April 30, 2008

Re: Draft North Coast Instream Flow Policy

**A Critical Review of the December 2007 State Water
Resources Control Board Draft Policy for Maintaining
Instream Flows in Northern California Coastal Streams and
Supporting Documents**

FIGURE 8-15
Project #6: Modeled impairment at limit of anadromy under Policy
Normal water year (Project yield this year = 7 AF)

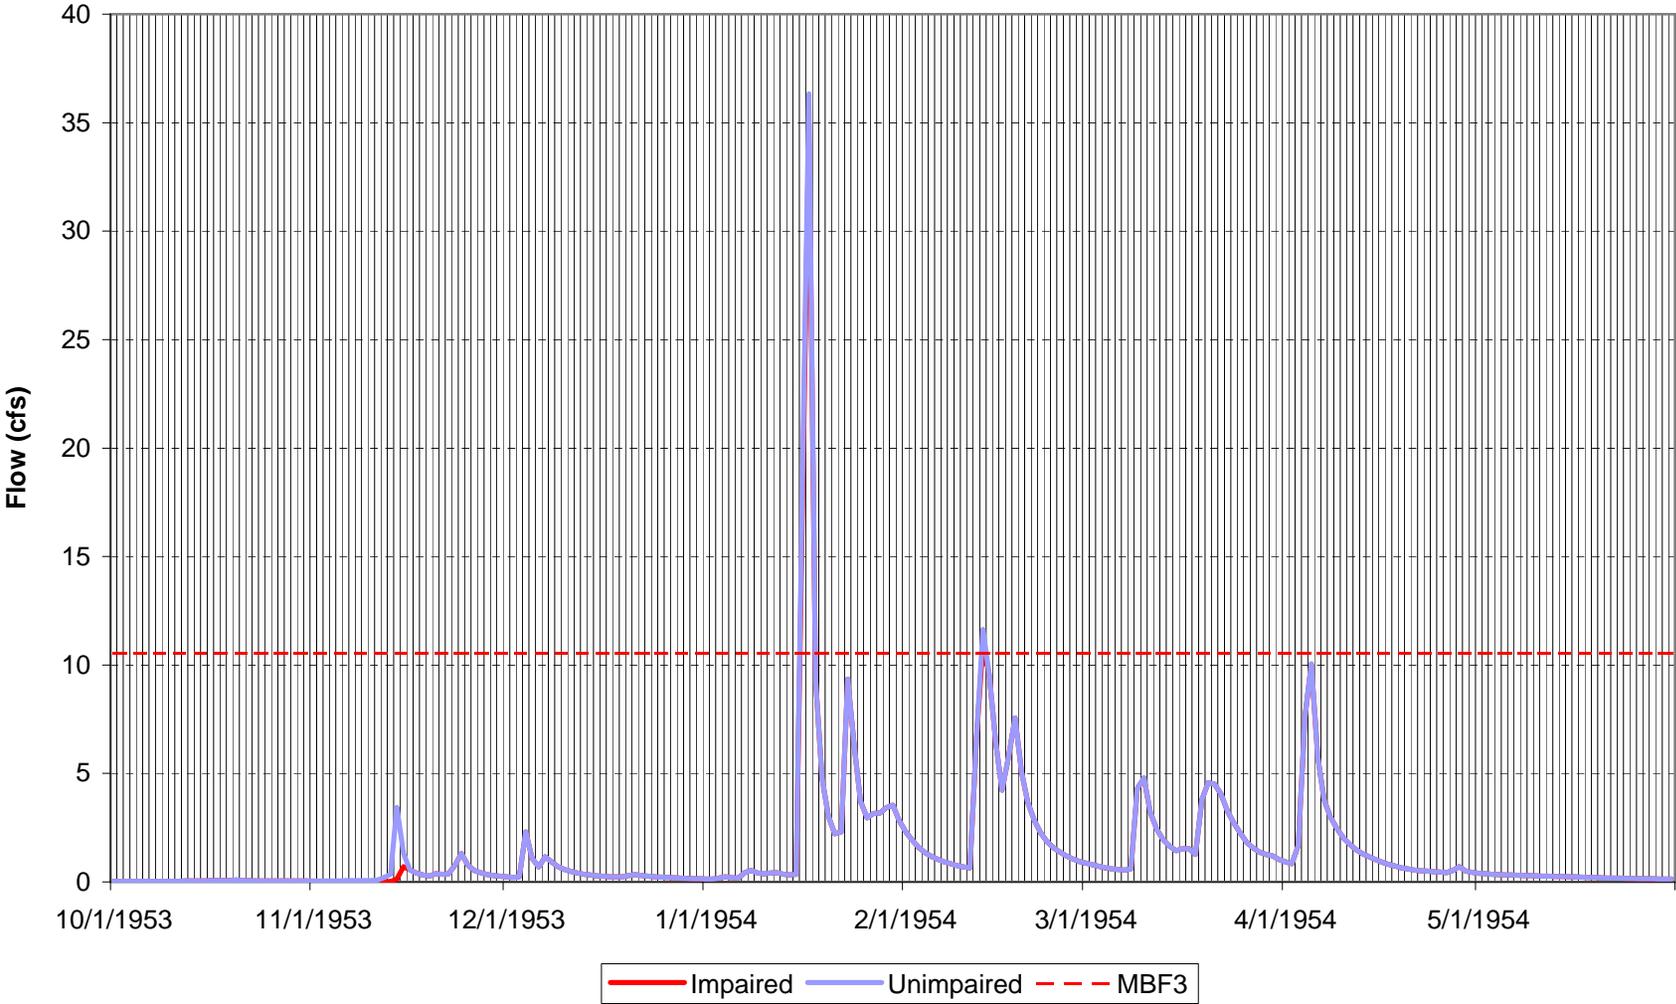
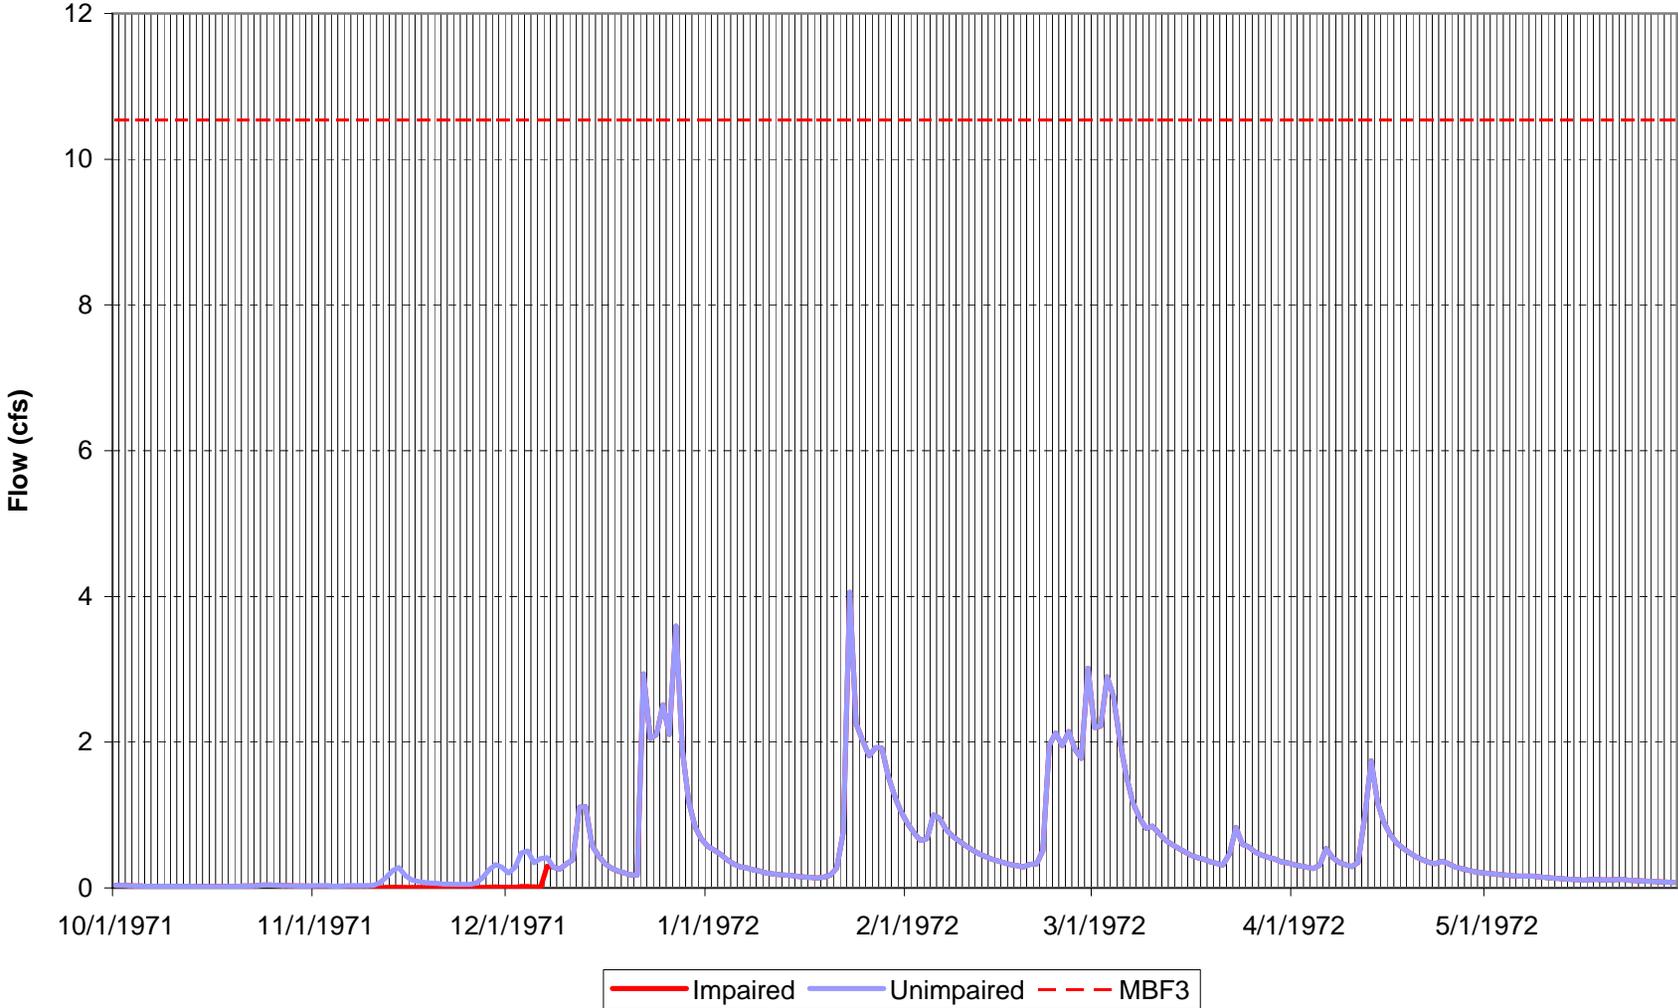
Figures 8-15 and 8-16 (attached) show diversions in a normal and dry year under the Draft Policy. The Policy minimum bypass is also shown. The impairment reflected early in the season in Figures 8-15 and 8-16 is due to other permitted rights upstream of Project #6. Project #6 is able to divert some water during the peak flow of January of the normal year. The average annual yield of this project under the Draft Policy would be cut to 9 AF, approximately one-third of the no constraint scenario.

FIGURE 8-17
Project #4: Modeled impairment at limit of anadromy with no diversion constraints
Normal water year (Project yield this year = 12 AF)

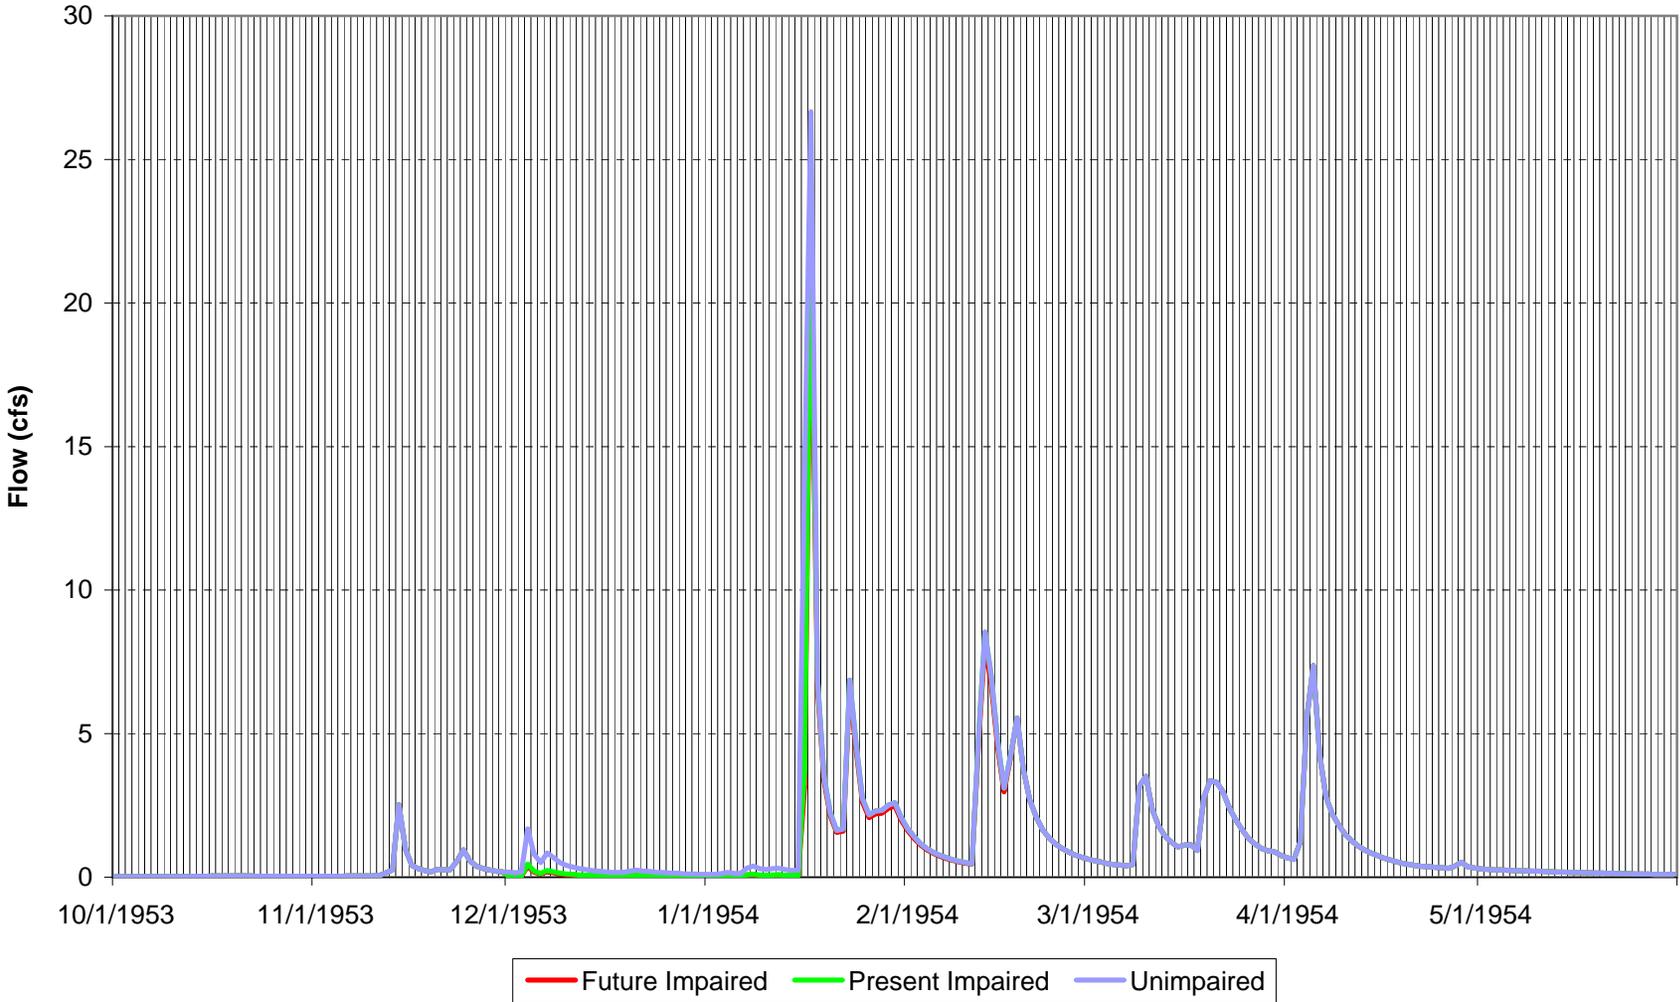
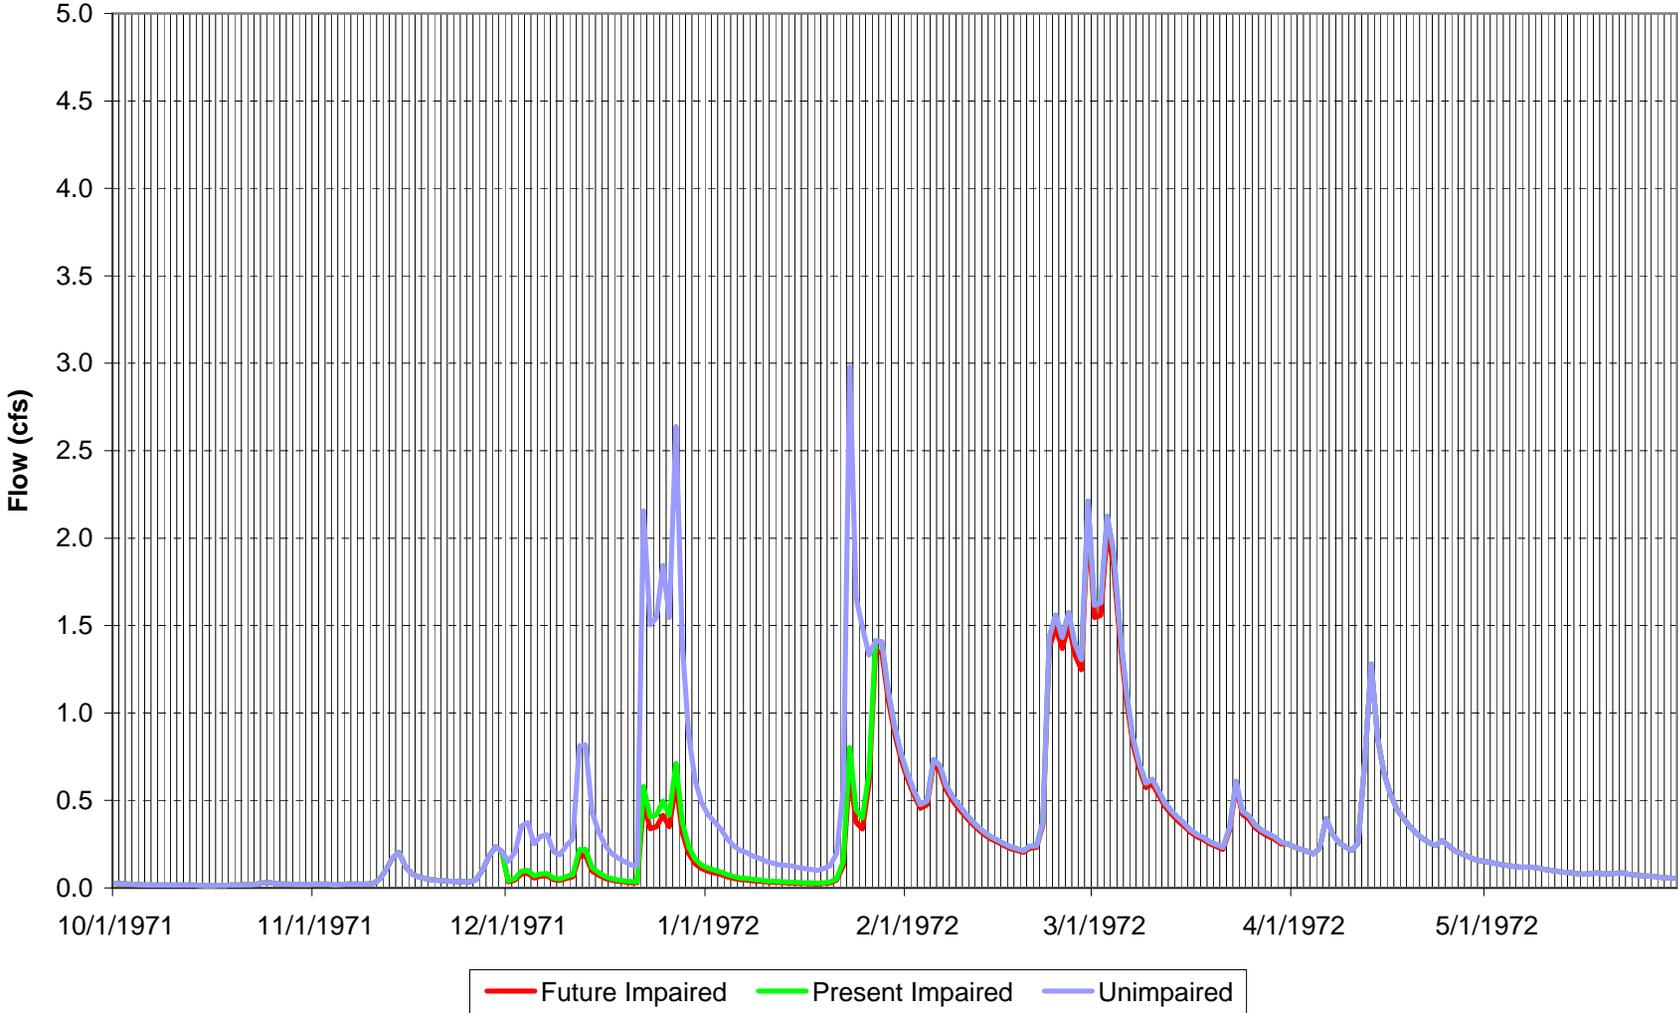
Figures 8-17 and 8-18 (attached) show the modeled impairment at the limit of anadromy in a typical normal and dry year, respectively. Note that there is a large, permitted existing reservoir between the project and the limit of anadromy. Thus, the hydrographs show a “present impaired” condition corresponding to operation of the permitted right. Project #4 diversions result in only a slight difference between the present impairment (green line) and future impairment (red line). The average annual yield of Project #4 under the no constraint scenario would be 10 AF. Under the Draft Policy, the project yield would be zero.

FIGURE 8-19
Project #12: Modeled impairment immediately below POD #1 with no diversion constraints
Normal water year

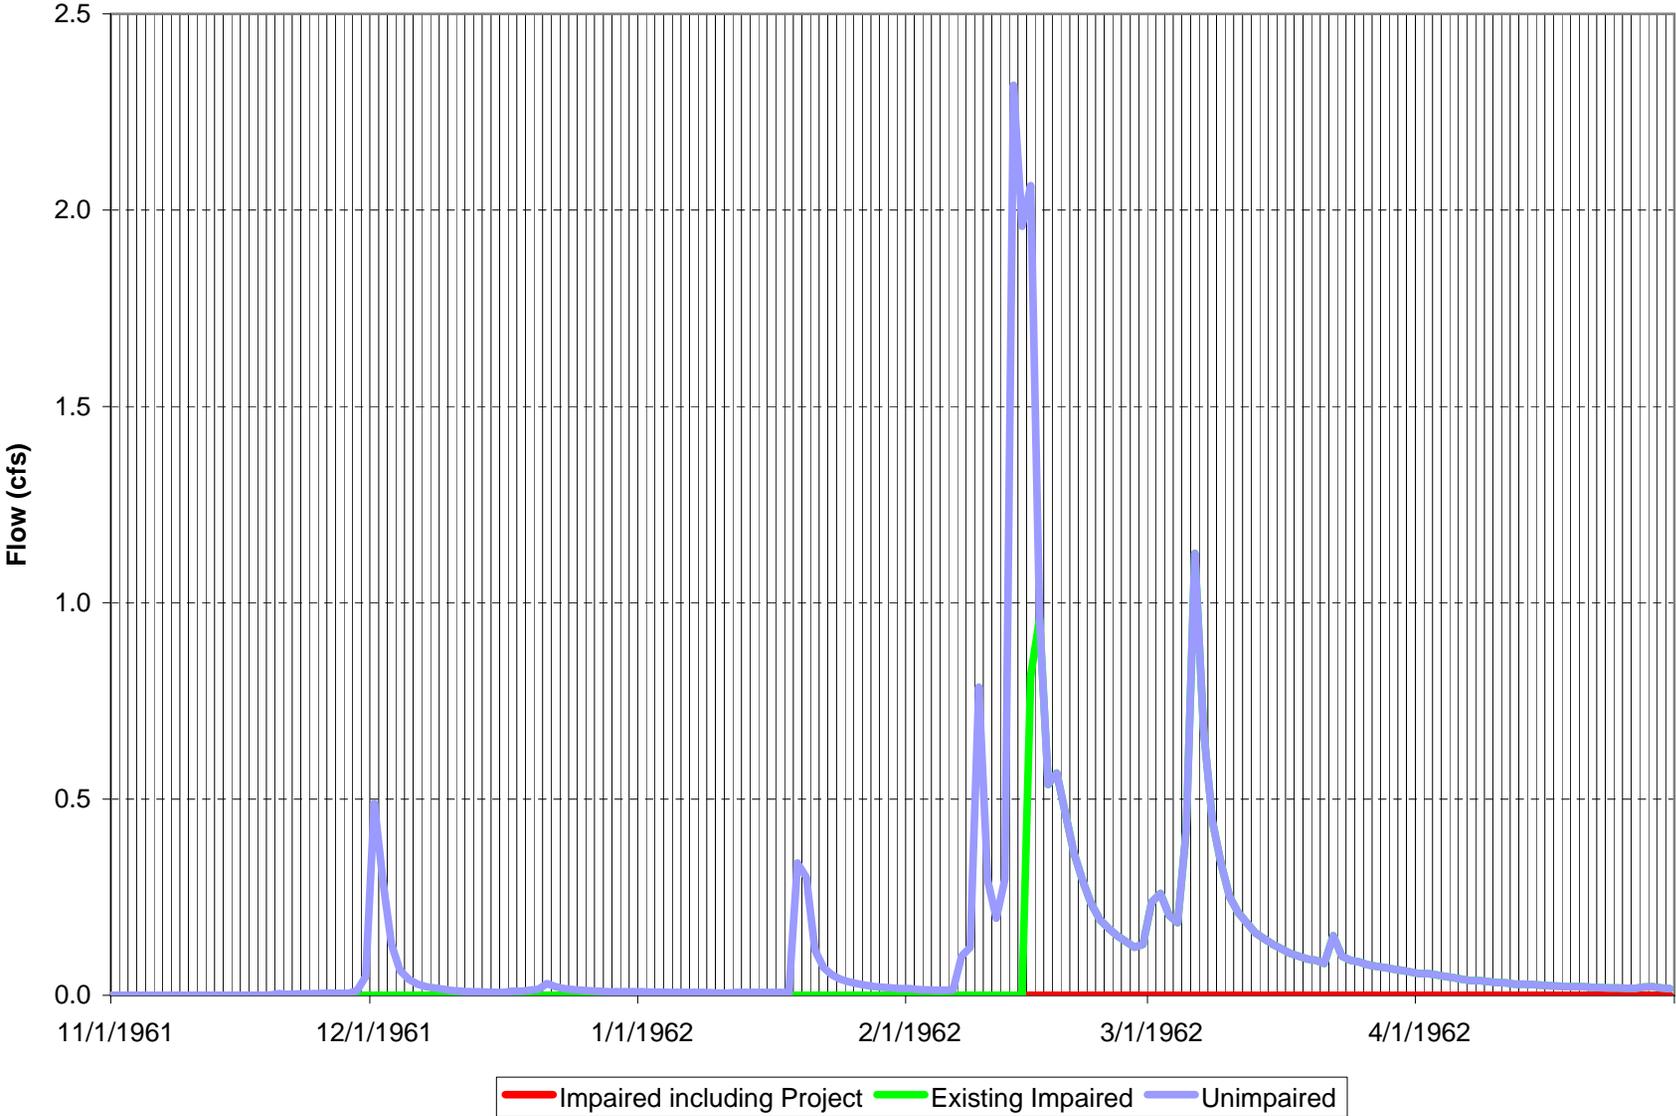
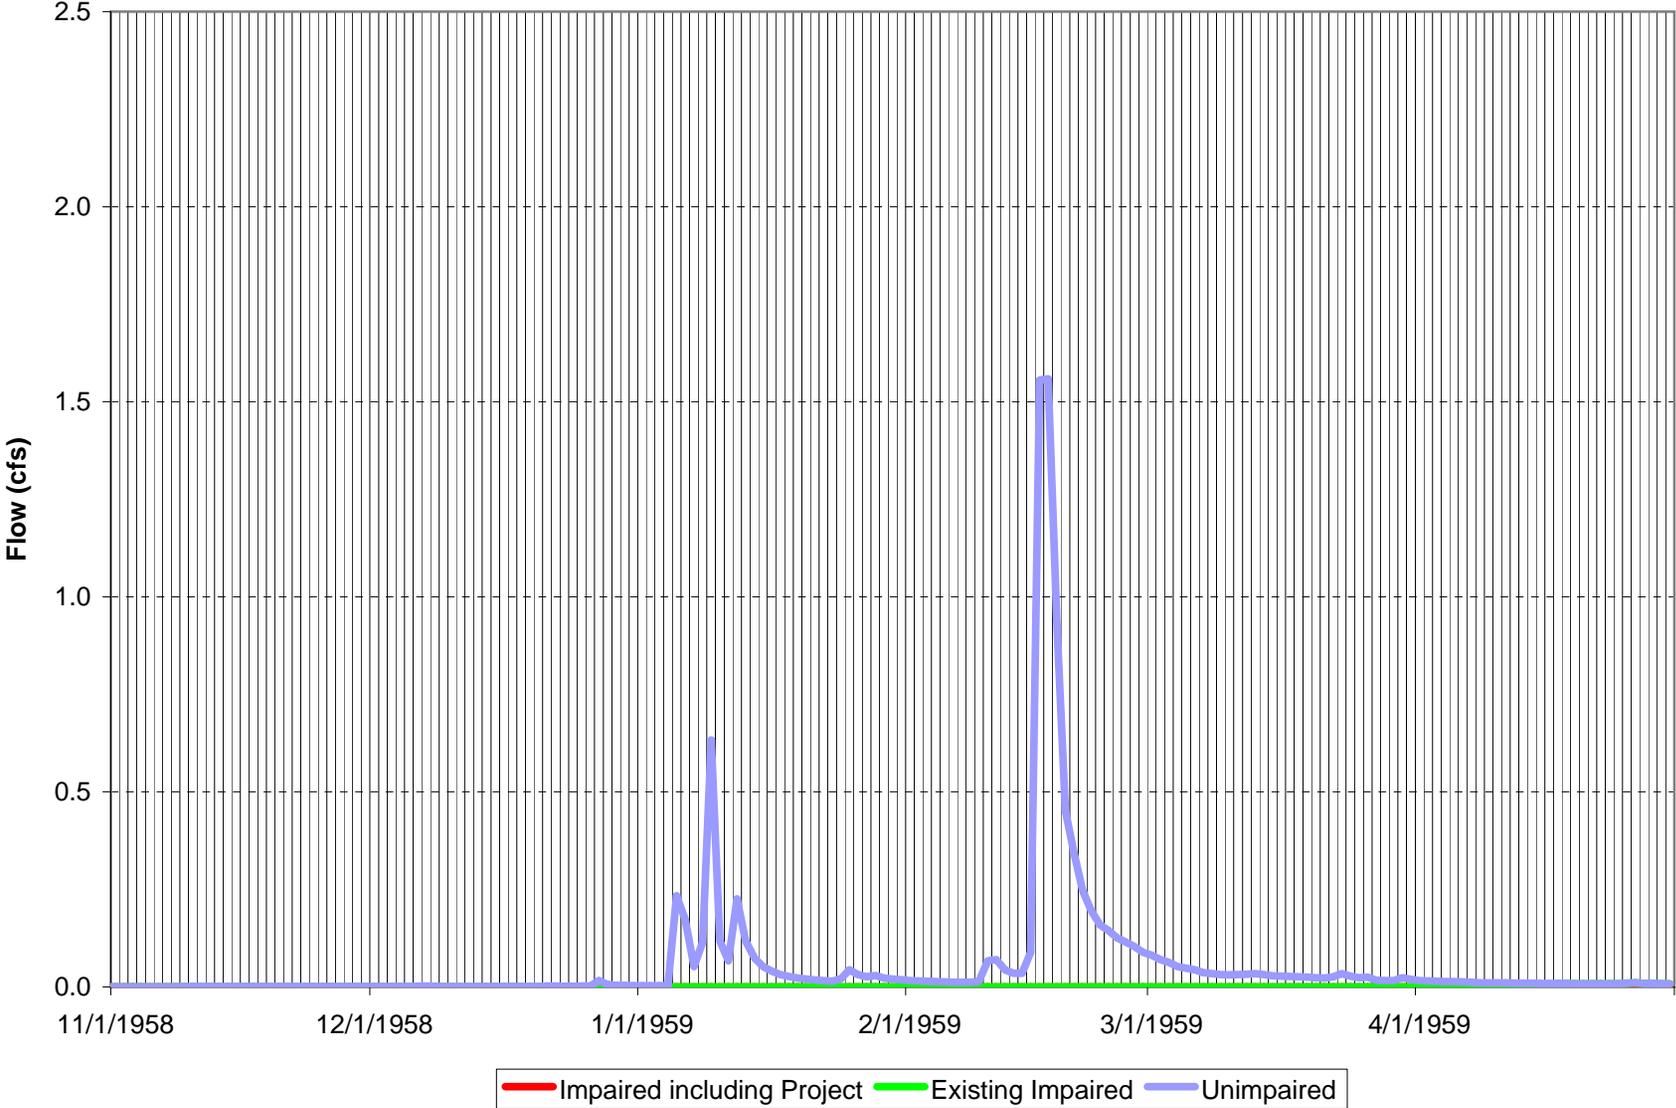
Figures 8-19 and 8-20 (attached) show estimated flows immediately below POD #1 in typical normal and dry years under the no diversion constraint scenario (i.e., fill-and-spill operation with no bypass). Under unimpaired conditions, there is no flow at the POD during most of the year. There are a few storm events, when 1 or 2 cfs flows for a few days. With the licensed storage in effect (shown by the green line), water is captured and no flow passes POD #1 until mid-February of the normal year and not at all in the dry year. The red line shows that the applied-for enlargement of the storage right would result in no flow passing POD #1 throughout the normal year.

Viewed from the perspective of Figures 8-19 and 8-20, it may appear that operating the project without diversion constraints would have a large impact. However, it is important to place this in perspective. At the project location, there are only a couple cubic feet per second of flow for a few days in a normal year. It is far above the limit of anadromy. And, there are no other water rights above this limit of anadromy. Figures 21 and 22 (attached) show the estimated streamflow at the limit of anadromy below POD #1 with the project operating with no diversion constraints. These figures show that at the limit of anadromy the difference between unimpaired flow and impaired flow is slight.
